Report for Wellington City Council

Community Street Review for Brooklyn, Wellington

Revised version, April 2009

2P *Full length of Brooklyn Terrace (a link section)*

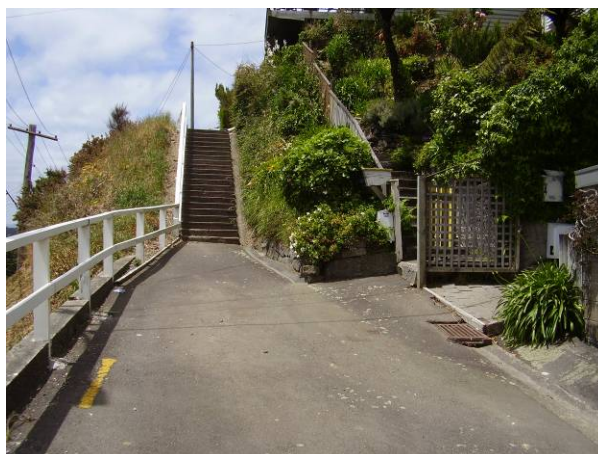
This pathway provided a pleasant walk away from the traffic, but was poorly maintained. The path is eroding, the bank is crumbling and the steps are uneven with corners missing. Personal safety was an issue and the two street lights were considered insufficient.

At the time of the review, a car was parked at the bottom of the steps, making access difficult. Rubble and twigs covering the pathway looks messy and could be dangerous underfoot.

- Improve surface quality, to ensure a smooth, safe walking environment
- Ensure regular clearance of street debris and litter
- Add extra street lighting
- Extend the yellow, no parking, lines to prevent vehicles blocking pedestrian access to the steps.
